# INFORMATION BULLETIN

PROJ.: Arlington Woods Free  
Methodist Church  
Renovation

DATE: Jan 15, 2021  
I.B. No. 004

Mixed-Use Space Hydronic Piping Removals

**DETAIL NO.:** 1/M4 & 2/M4

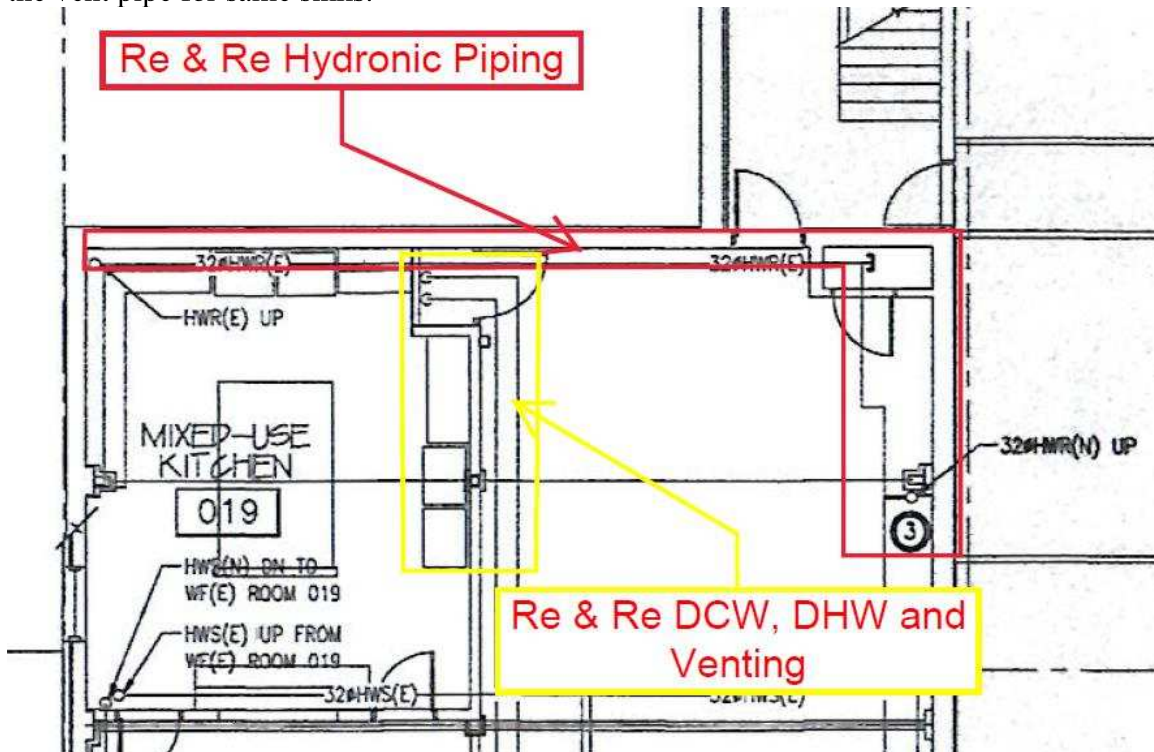
The Hydronic piping in the Basement ceiling running along GL-E is attached to the underside of the existing high joists. This piping will have to be removed, temporarily capped and then reinstalled after the new joists are installed.

The same issue applies to the DCW and DHW lines that feed the Kitchen sinks as well as the vent pipe for some sinks.

This work was not captured on the Drawings and thus our Mechanical Contractor did not allow for this work in their price. Please issue a formal CCN or Site Instruction in order for us to get pricing.

1. Refer to newly-issued Mechanical Drawings, Issued For Construction, dated 2021-01-14 (Drawing 1/M4) for extent of new removals to existing DCW / DHW & HWR piping in Mixed Use Space ceiling where floor above is slated for removal.
2. Refer to drawing 2/M4 for extent of new utilities work.

**Refer to AIB-004, dated Jan. 15, 2021**
